## CITY OF SANTA ANA

## TENANT IMPROVEMENT PLAN CHECK COMMENTS

PLAN CHECK NO: 10173394  
PROJECT ADDRESS: 307 N Spurgeon St  
PLAN CHECK ENGINEER: Mazarji, Zac TEL: 714 647-5831  
FAX: 714 647-5897  
TYPE OF CONSTRUCTION: III B, SPK  
OCCUPANCY CLASSIFICATION(S): A-2  
PLAN CHECK DATES: APPLICATION 10/10/2011  
INITIAL REVIEW 10/11/2011  
EXPIRATION 4/7/2012  
RECHECKS: 1.  
2.  
3.  
REMARKS/RECHECK ITEMS:  
PROJECT APPLICANT CONTACT PERSON:  
493-2050  
667-0174  
is.luy@gmail.com  
VALUATION: \$25,000.00  
FLOOD ZONE: X-0602320276

## REVISION/SUPPLEMENTAL PLAN CHECK REQUEST

# RAIL DETAIL

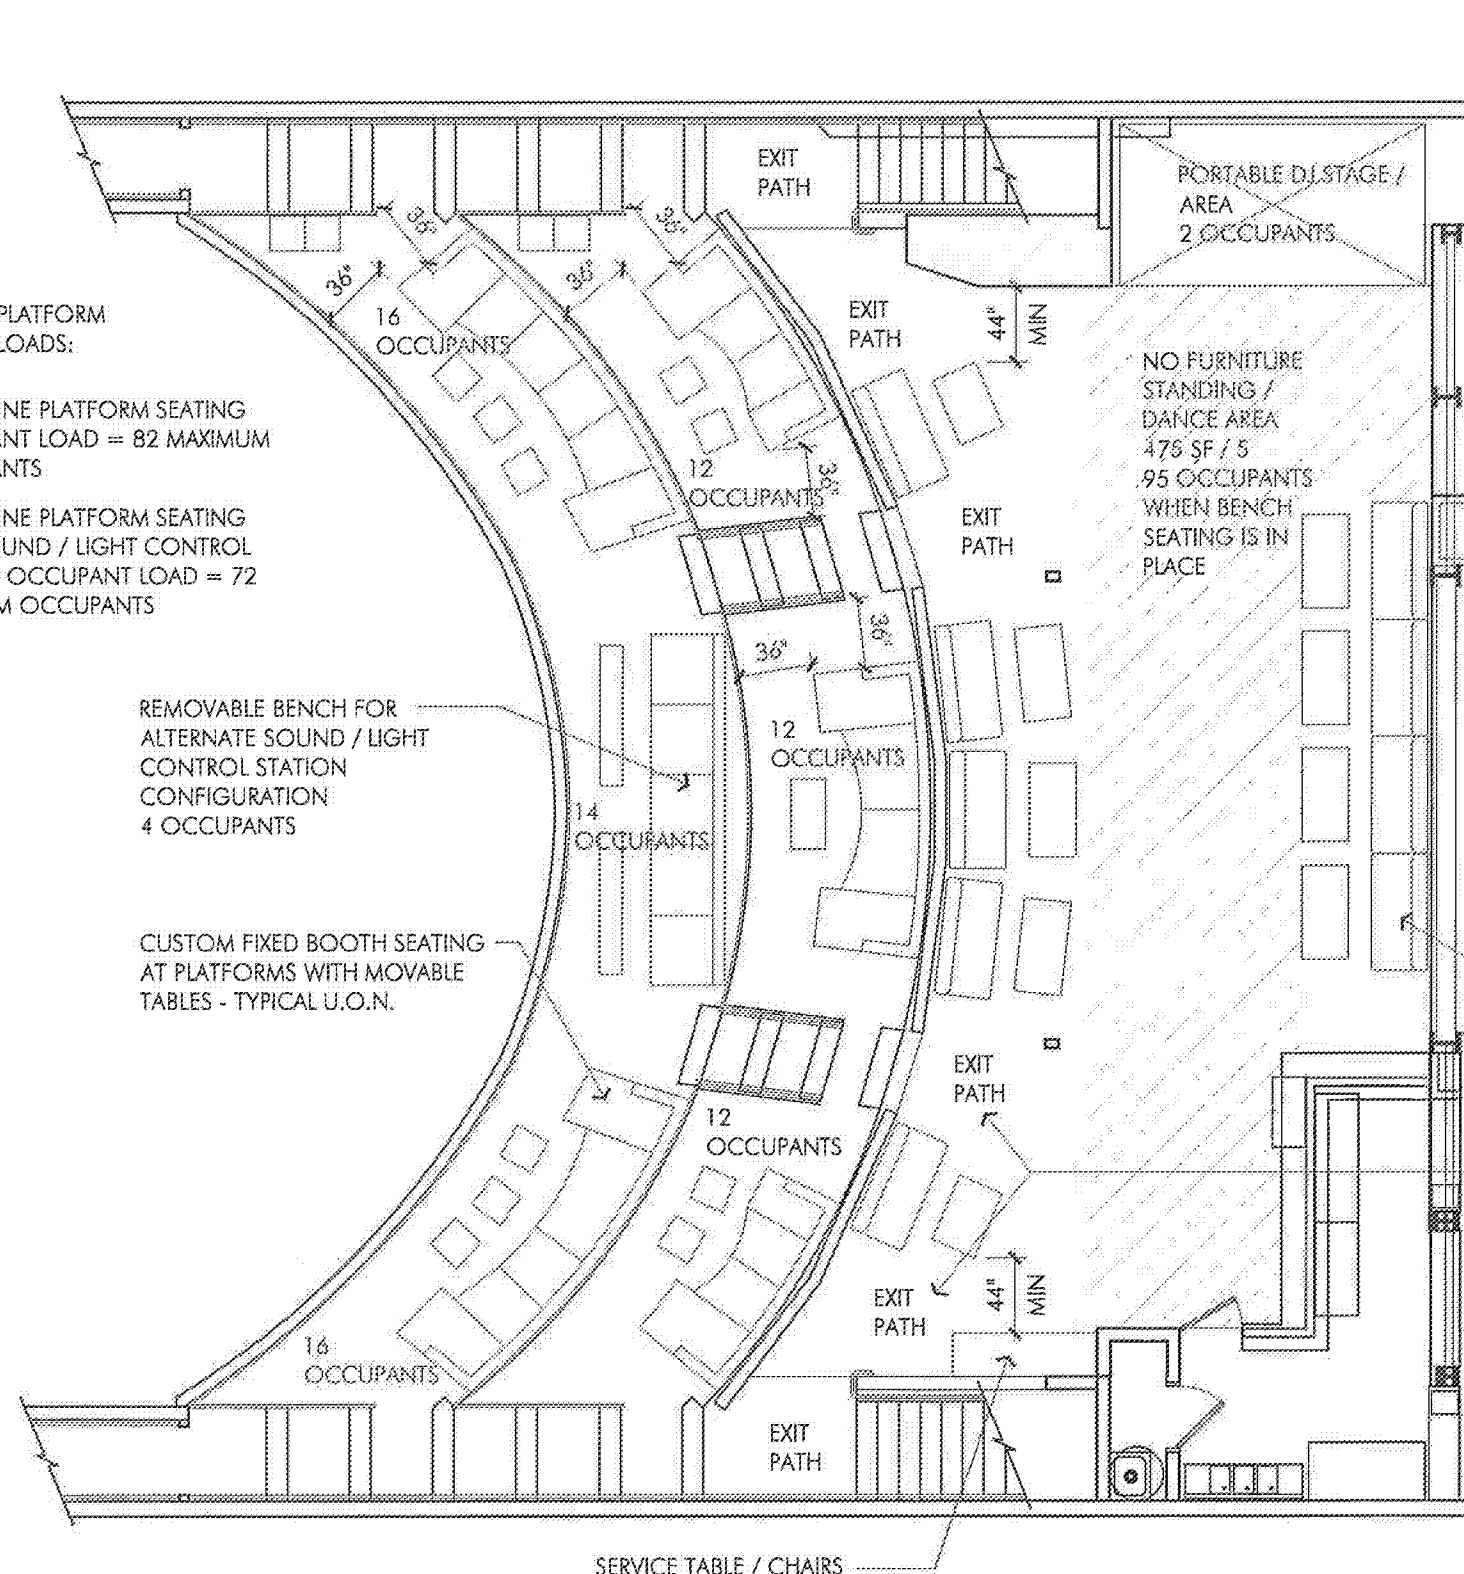
10. Provide handrail details on the drawings showing compliance with CBC Section 1009.10, 1012, and 1133B.4.1. Please note new dining area requires handrails on both sides. Please see attached handout and revise drawings to show compliance.

12. CBC Section 1013.2. The top of the guards shall not be less than 42" in height.
13. CBC Section 1013.3. Open guards shall have intermediate rails or an ornamental pattern such that a sphere 4" in diameter cannot pass through.

# RAIL DETAIL

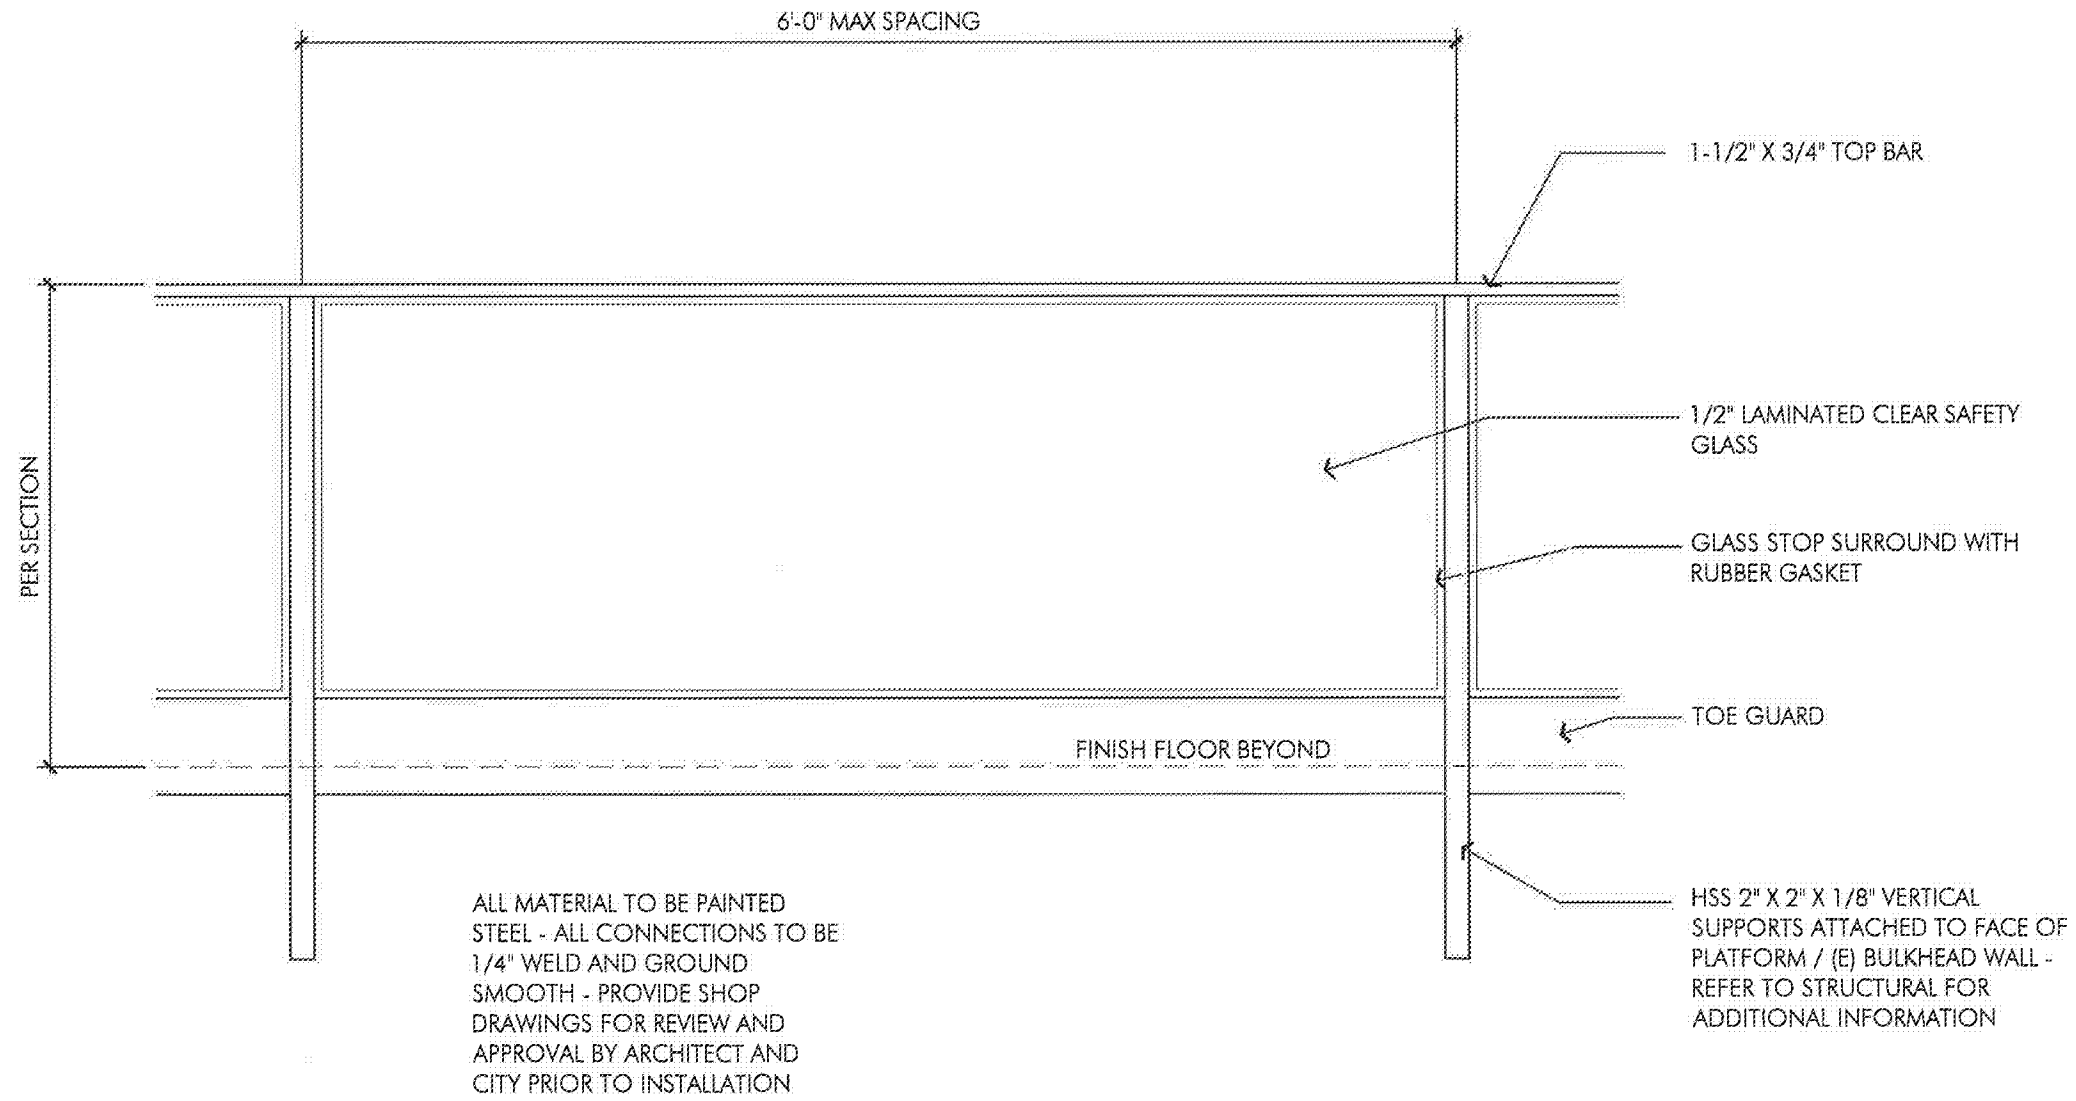
✓ 10. Provide handrail details on the drawings showing compliance with CBC Section 1009.10, 1012, and 1133B.4.1. Please note new dining area requires handrails on both sides. Please see attached handout and revise drawings to show compliance.

- Stairways shall have handrails on each side.
- Handrails shall be 34 to 38" above the nosing of treads.
- Handrails shall extend a minimum of 12" beyond the top nosing, and shall extend a minimum of 12" plus the tread width beyond the bottom nosing.
- The handgrip portion of handrails shall not be less than 1 1/4" nor more than 1 1/2" cross-sectional dimension or the shape shall provide an equivalent gripping surface. The handgrip portion of handrails shall have a smooth surface with no sharp corners. Any wall or other surface adjacent to the handrail shall be free of sharp or abrasive elements. Edges shall have a minimum radius of 1/8".

# FURNITURE / OCCUPANCY PLAN

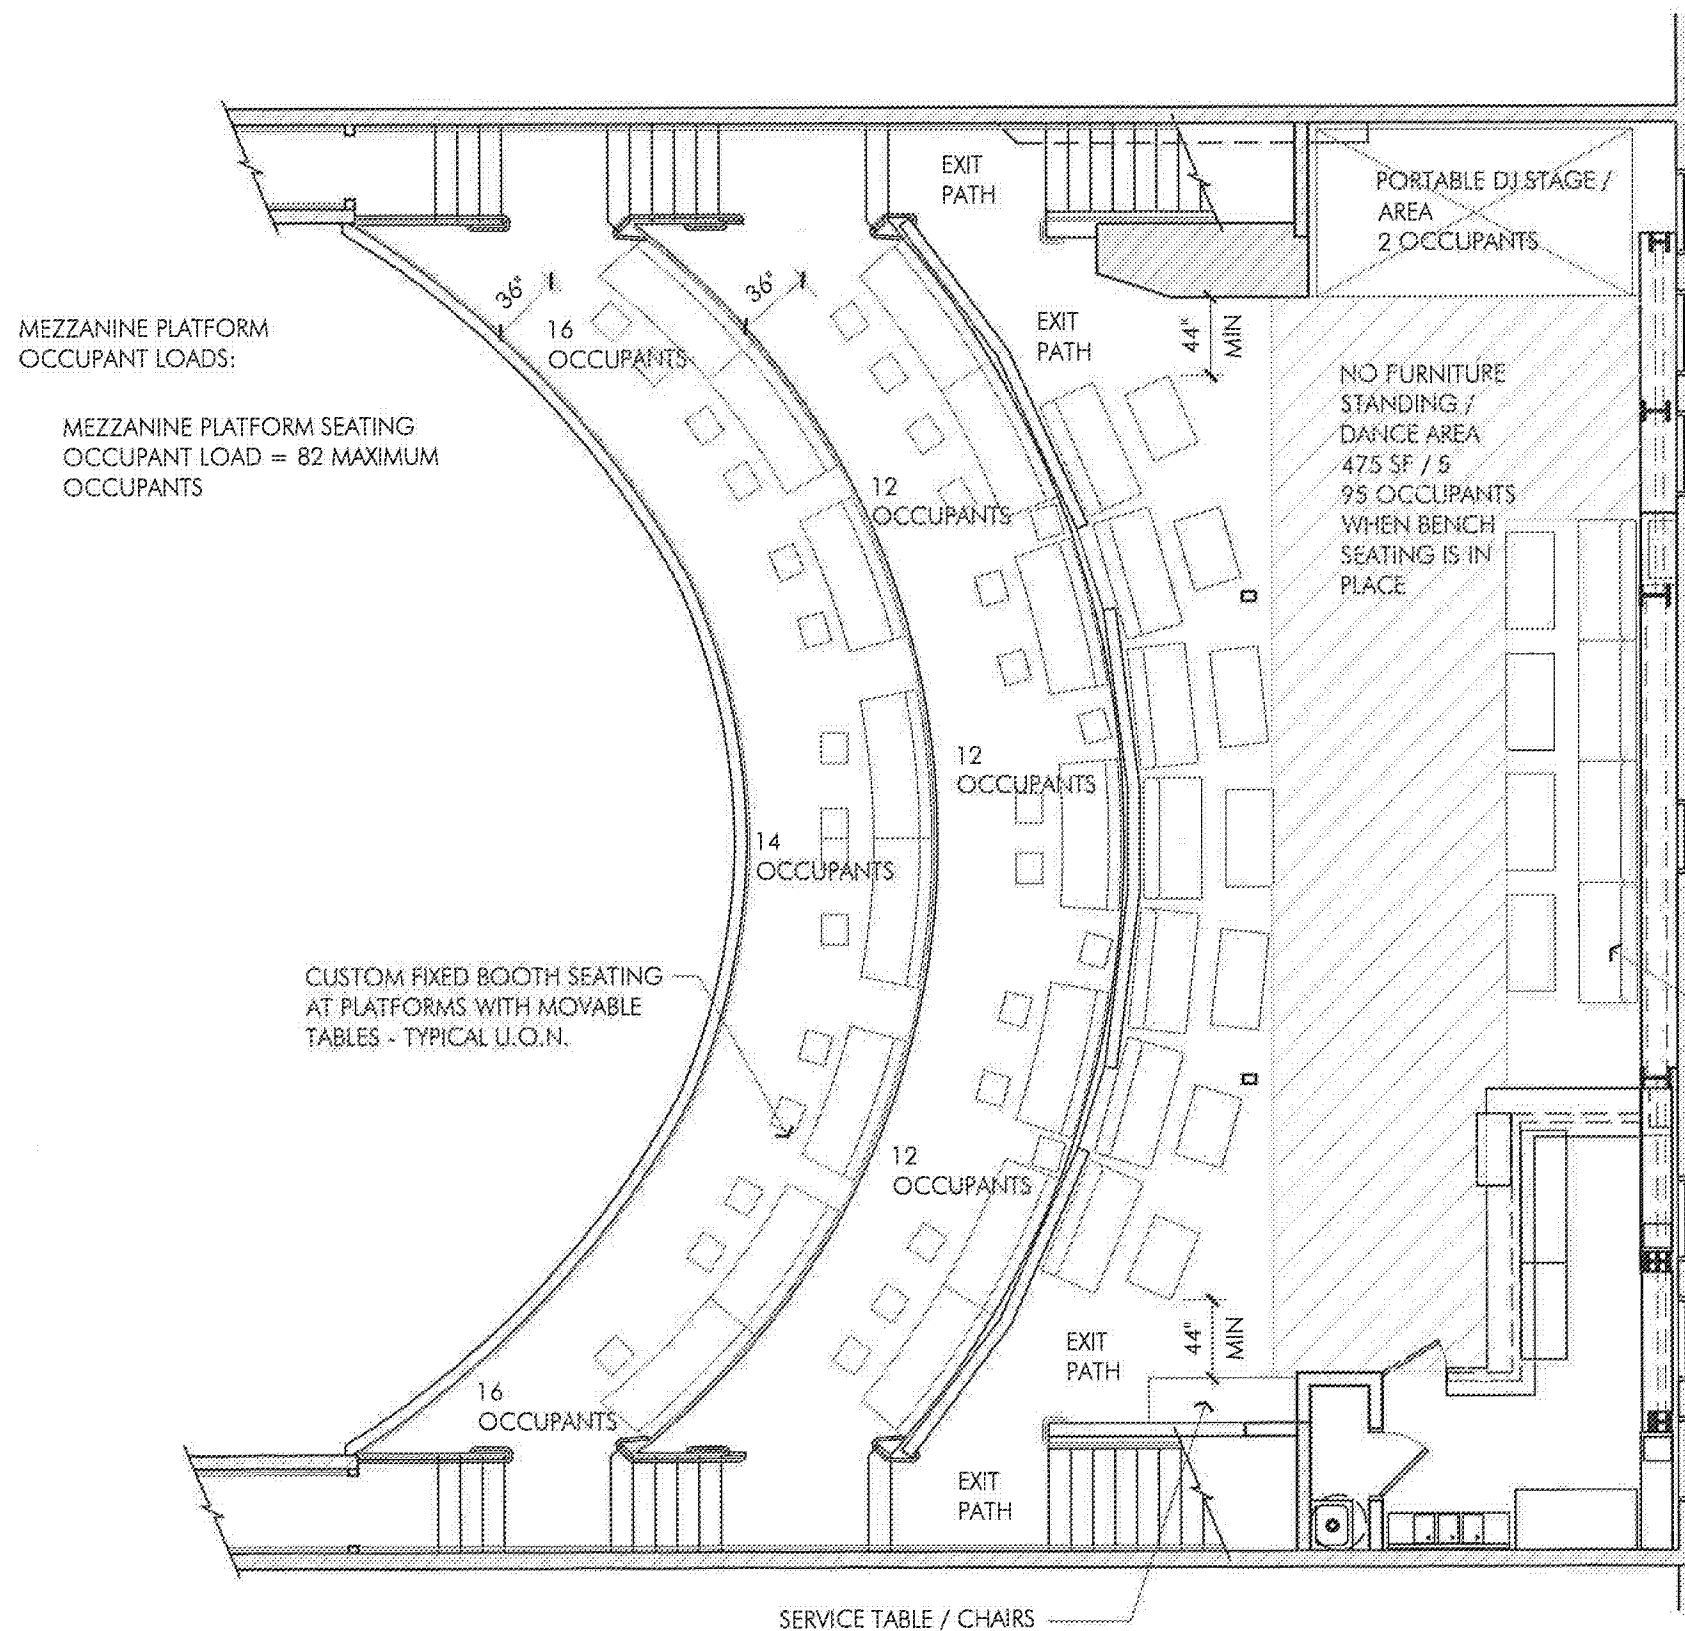
- ✓ 14. Please clarify location of landing from each side of new dining area when used as exit way.
- o ✓ 15. Refer to the attached Accessibility hardship form and complete to show compliance with Section 1120 B.1.2 of CBC for proposed dining room on the mezzanine level. (No elevator to mezzanine level).
